Town of Duanesburg
Planning Board Minutes
March 17th, 2022
Final Copy

**TOWN OF DUANESBURG PLANNING BOARD
RESOLUTION APPROVING AMENDED SPECIAL USE PERMIT AND AMENDED SITE
PLAN
FOR TWO 5 MW SOLAR PROJECTS BY OAK HILL SOLAR 1 LLC and OAK HILL SOLAR
2 LLC**

March 7, 2022

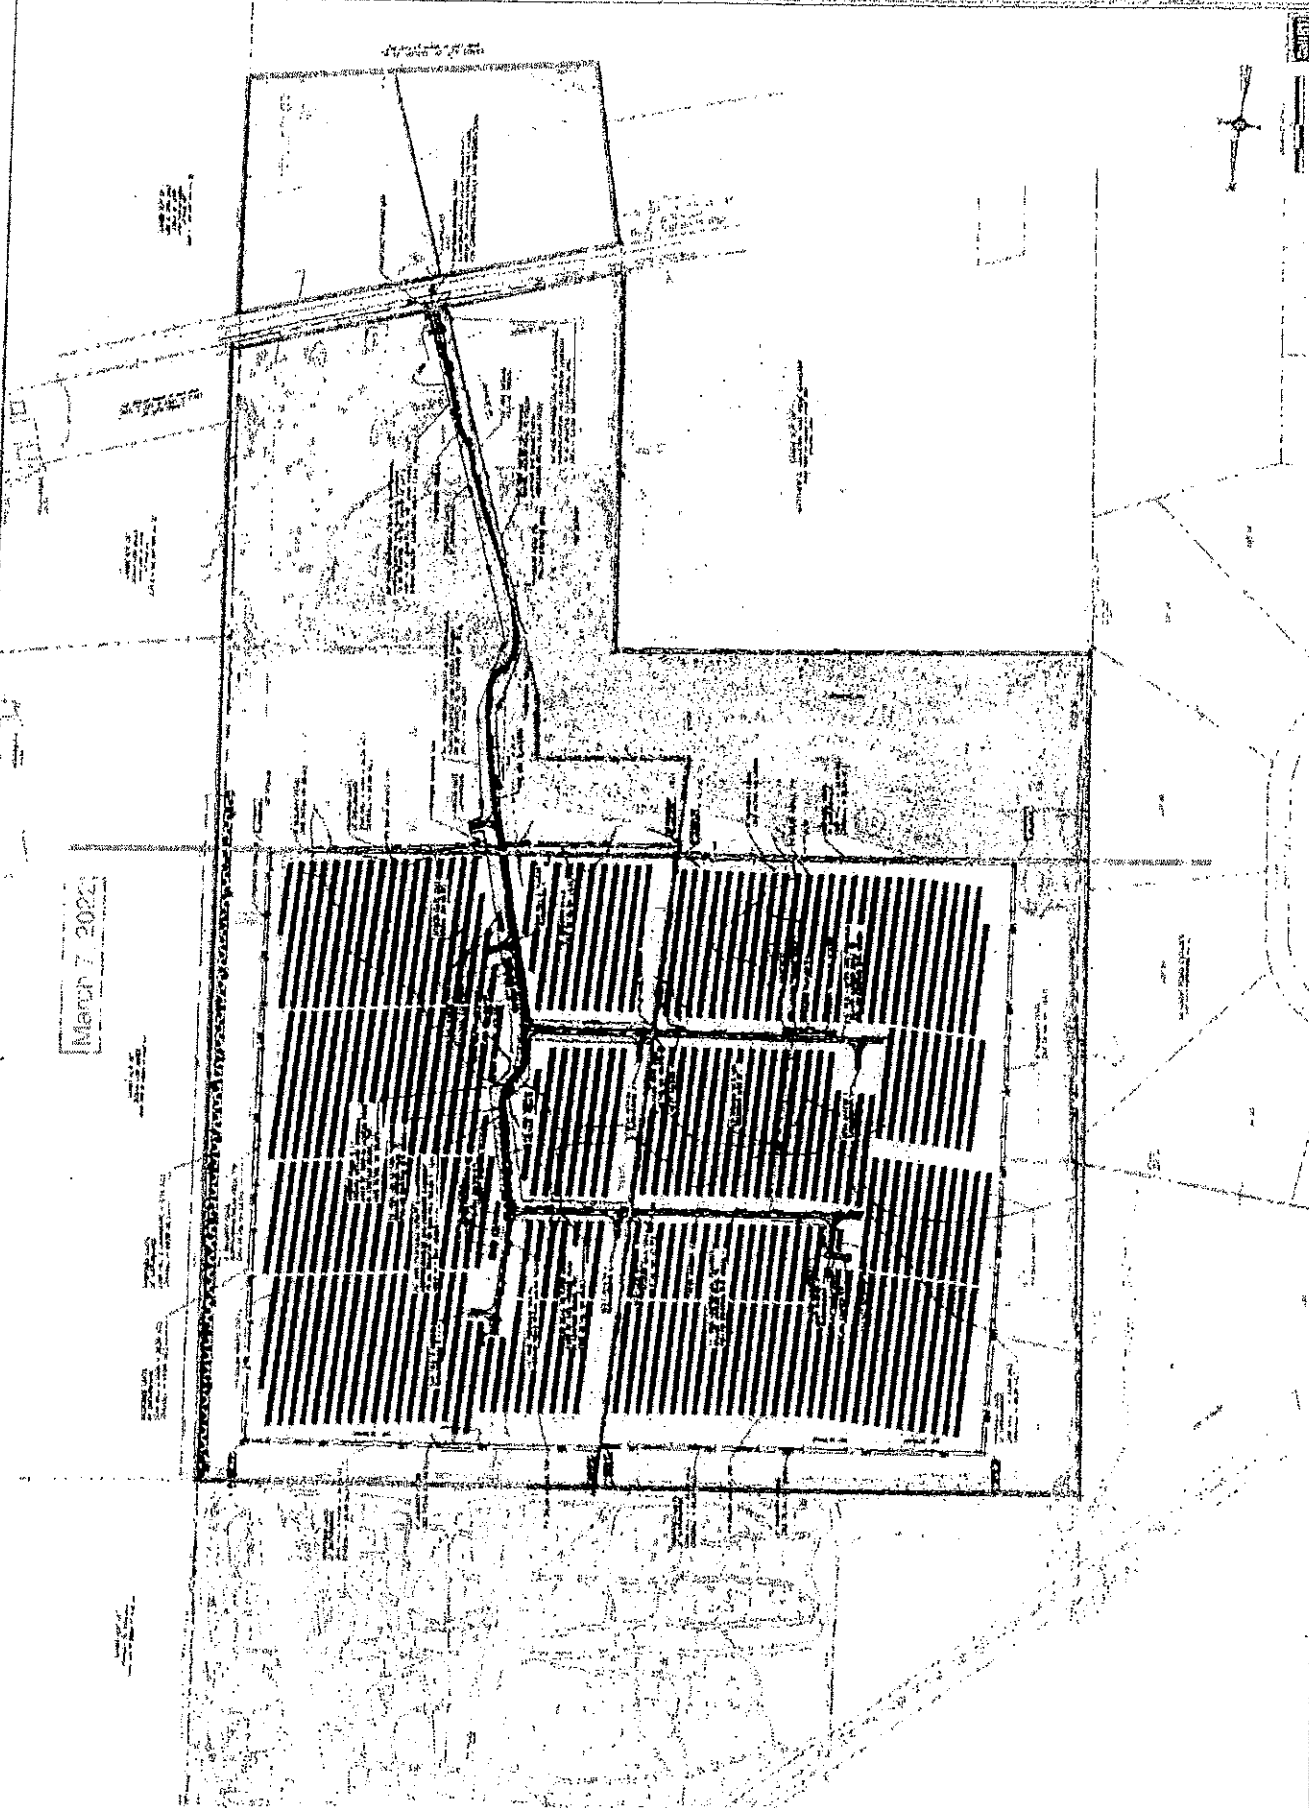
of the May 7, 2018 sketch/site plan to the March 11, 2019 site plan sheets 1 to 10, September 5, 2019 Sheets 1 to 11, and the March 7, 2022 Drawing C2.00 Sheet 8 of 30, s upon acres of deforestation. SEQR began July 2018 and ended July 2019. It Oak Hill Solar may have violated SEQR 617.3(c) prohibiting site disturbance while under review. The Applicant may have violated Solar Law 3.f and 3.i limiting 1 to 20,000 square feet. I request that the state and town enforce the laws that ls from deforestation.

March 7, 2022 Amp / Greencells / Vandanterra to Board Revision G Drawing C.2.00. Sheet 8 of 30 annotated in color to show tree-line

2022 03 07 Sheet 27 Landscape Oak Hill IFC Plans Stamped Signed.pdf
7141K

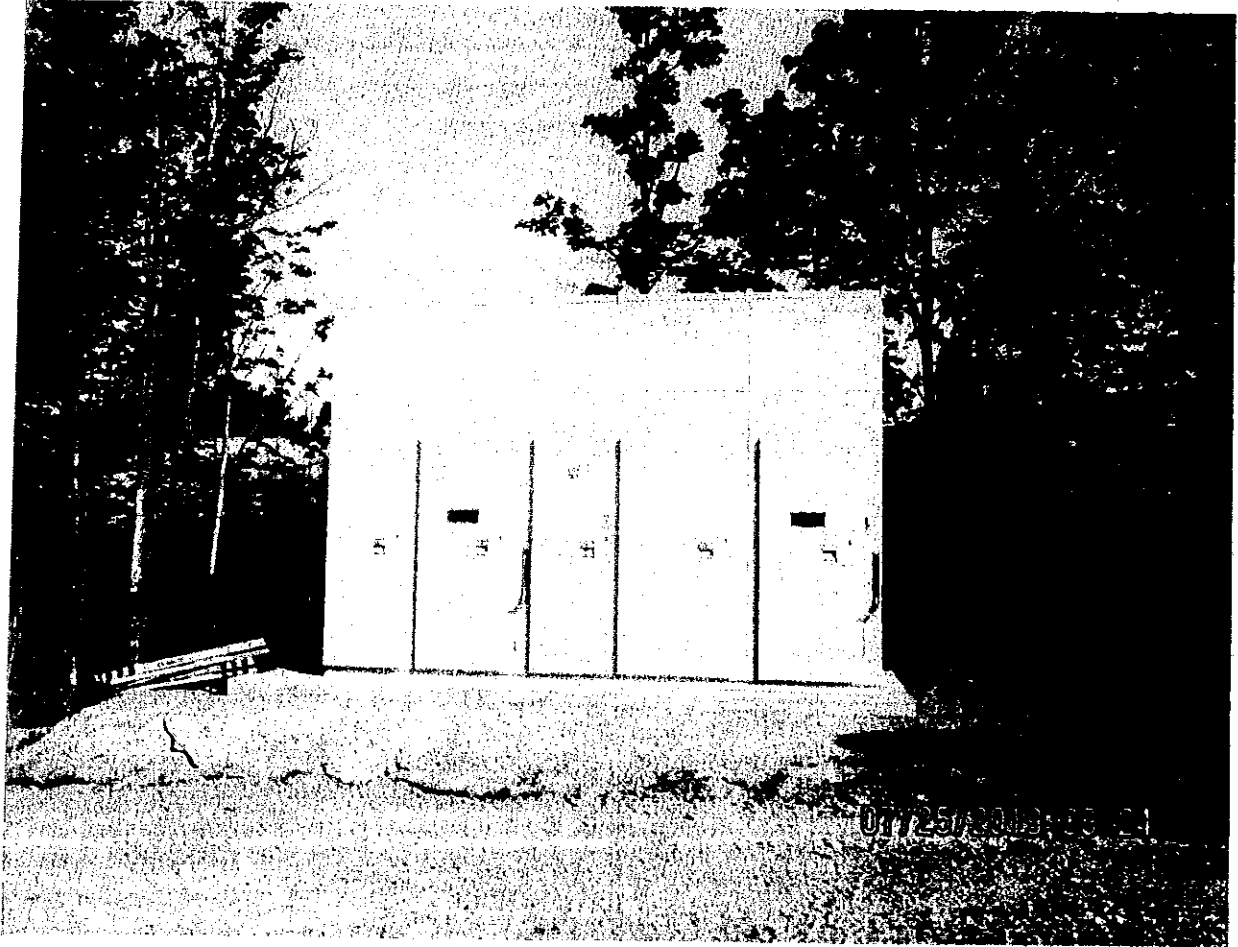
Drawing C2.00 C3.00, C7.00, and other drawings, still omit the nearest house to the west of the Project site. Matt Ganster's house on tax id 74.00-2-6 is omitted. This may deprive the Ganster family of fair and honest representation over the lifetime of the Project. Attached is a PDF of the March 7, 2022 Revision I Drawing C7.00 Sheet 27 of 30 showing that the house is omitted.

Drawing C7.00 Sheet 27 of 30 shows the incorrect treeline and vegetative cover for the abutting parcels to the east. The Project site has little to no vegetation on its east property line. The Project relies on the abutting neighbors to screen their own view of the 14.5 feet in height tracking panels, 8 feet in height fence, and other energy equipment on their own land. The developer's project limits the abutting landowners use of their own lands for the lifetime of the Project. This is grossly unfair. The developer should screen their entire project with evergreens and maintain the evergreen for the lifetime of the Project. The developer should correct their misrepresentation and stop misleading the board.

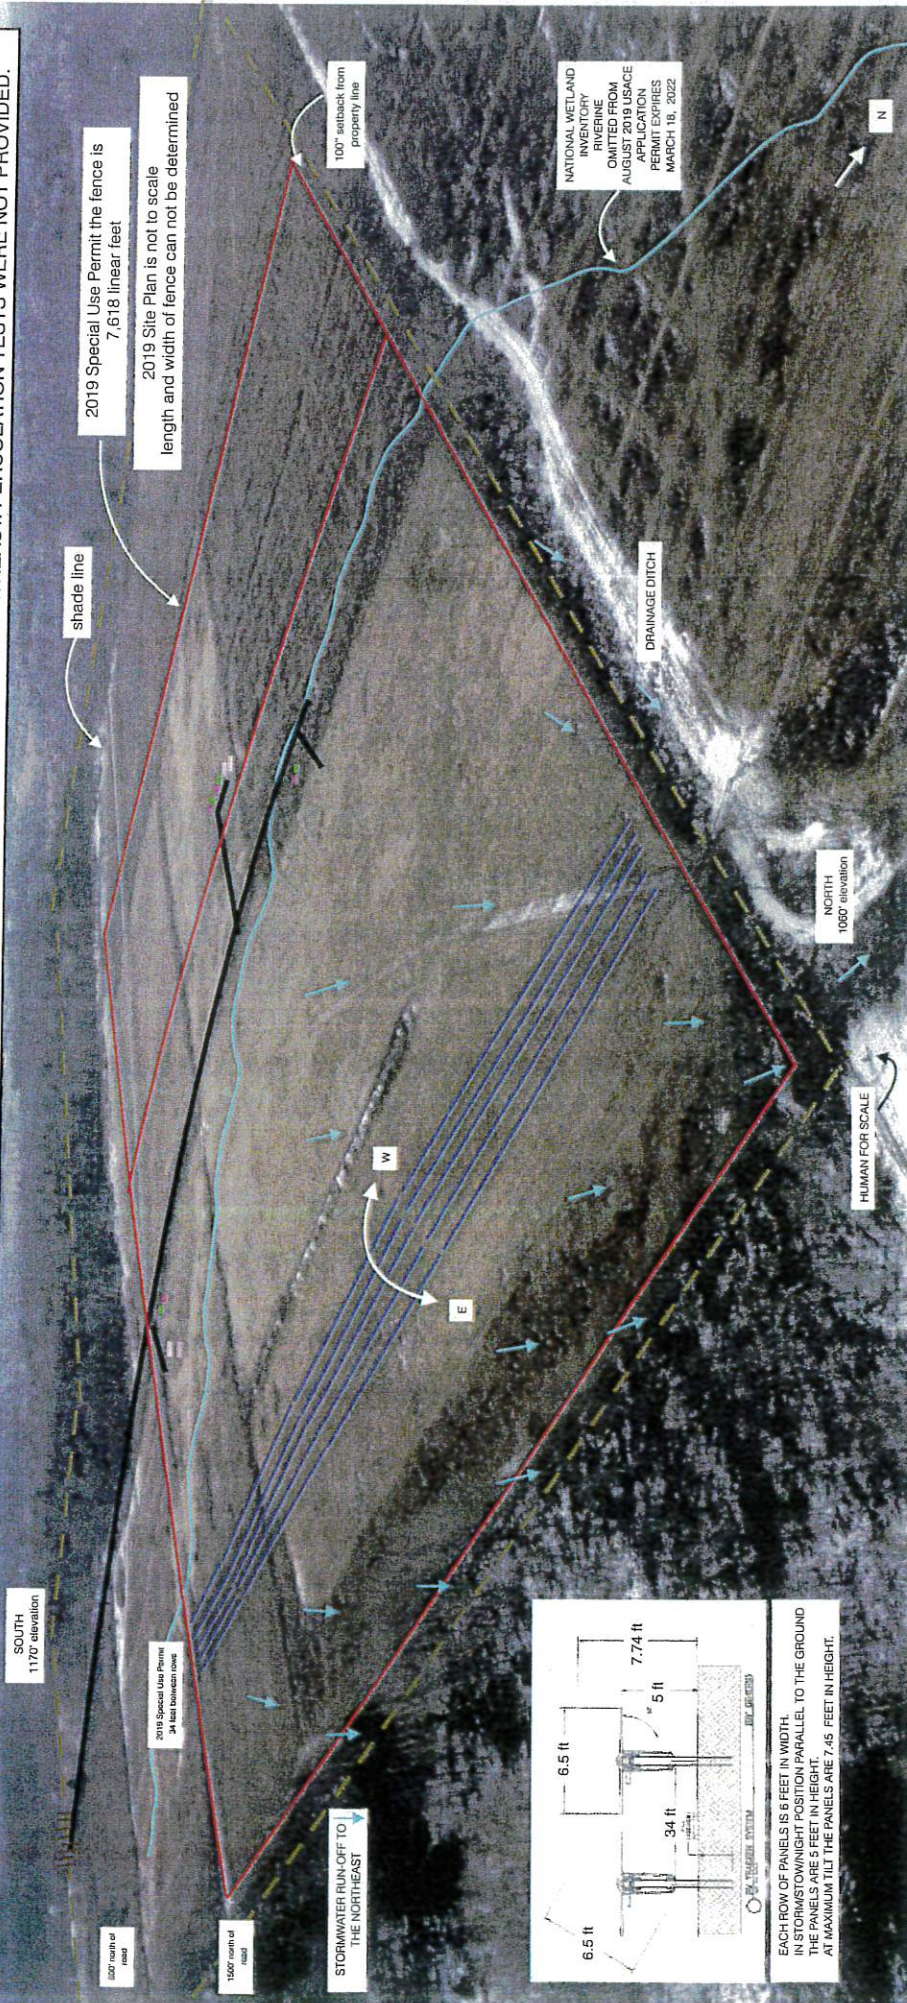
THE SITE PLAN SHOWS FOUR TRANSFORMERS, FOUR INVERTERS, AND FOUR SPARE PARTS CONTAINERS. AT THE INTERCONNECTION POINT, DUANESBURG ROAD, THERE ARE EIGHT (8) UTILITY POWER POLES SHOWN ON THE SITE PLAN.

THE DECOM PLAN REFLECTS TWO (2) MAJOR SWITCH GEAR NEITHER IS SHOWN ON THE SITE PLAN. THE DECOM PLAN SHOWS "120 STRING INVERTERS, STORAGE AND DC CONVERTERS". NONE OF THESE ITEMS IS SHOWN ON THE SITE PLAN.

THE SITE PLAN OMITTS THE NEAREST HOMES TO THE EAST AND TO THE WEST, OMITTS NATIONAL WETLAND INVENTORY, AND HAS A COMBINED 7,618 LINEAR FEET OF FENCE. THE FENCE IS NEARLY 1,500 FEET NORTH OF DUANESBURG ROAD. THE FENCE IS 6 FEET IN HEIGHT WITH WOODEN FENCE POSTS AND 4" FIXED KNOT WIRE FENCING SEQR BEGAN 2018 AND ENDED 2019. SATELLITE IMAGES SHOW THAT THE SITE WAS CLEAR CUT MORE THAN 10 ACRES BETWEEN OCTOBER 2018 AND MARCH 2019.

WAS STATE ENVIRONMENTAL QUALITY REVIEW LAW 617.3(a) VIOLATED?
